1988/1989 GL1500 IMPROVED WINDSHIELD SEAL

(This supersedes GL1500 #5, dated November 1989)

An improved windshield seal for 1988 and 1989 GL1500s is now available. This thicker seal is used on the 1990 GL and helps retain the shield in its fixed position.

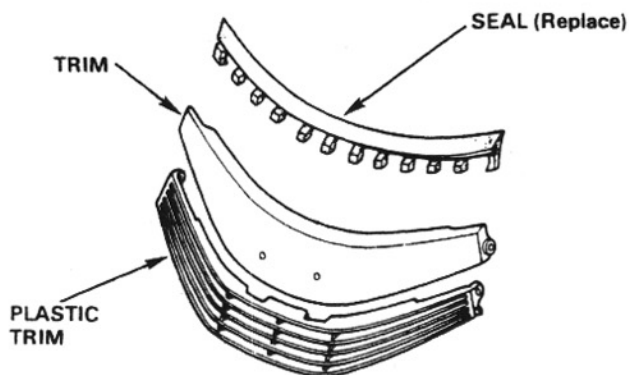
In addition to the new seal, properly adjusting the windshield lever anchor screws will prevent a loose or slipping shield.

5. Peel off the tape backing on the new seal. Press the seal into position on the trim.

6. Slide the trim tabs into the fairing slots and secure the trim with the two screws.
7. Adjust the windshield lever anchor screws according to service manual page 13-4.
8. Install the plastic vent trim and the mirrors.
